Exhibit 3.2

Hodges Creek Matrix of Required Retrofits to Public and Common Use Areas

HODGES CREEK APARTMENTS: PUBLIC AND COMMON USE AREAS

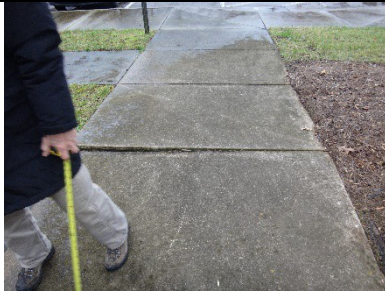
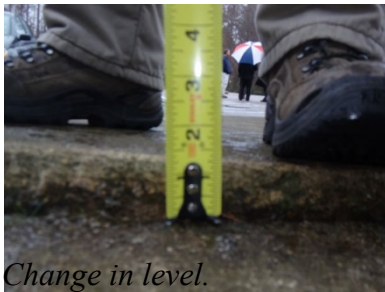
Numbers	Photos	Deficiency	Required Retrofit
5	 	The side wall grab bar at the women's restroom extends 51-1/4 inches from the rear wall (minimum 54 inches required).	Relocate grab bar to comply with ANSI 4.17.6.

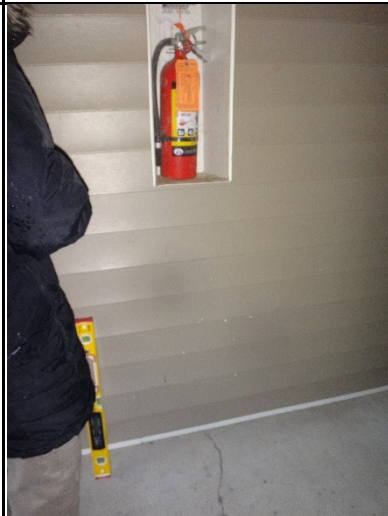
Numbers	Photos	Deficiency	Required Retrofit
8	 <p><i>Hardware at men's restroom door.</i></p>	The men's and women's restroom doors have locking hardware which requires tight grasping, pinching, or twisting of the wrist (not allowed).	Modify hardware to comply with ANSI 4.13.9
B. INACCESSIBLE ROUTES AT COMMON AREAS <u>Routes from Site Arrival Points to Common Areas and Covered Dwelling Units</u>			
<u>Inaccessible Features – Hodges Creek</u>			
	Lack of Accessible Route
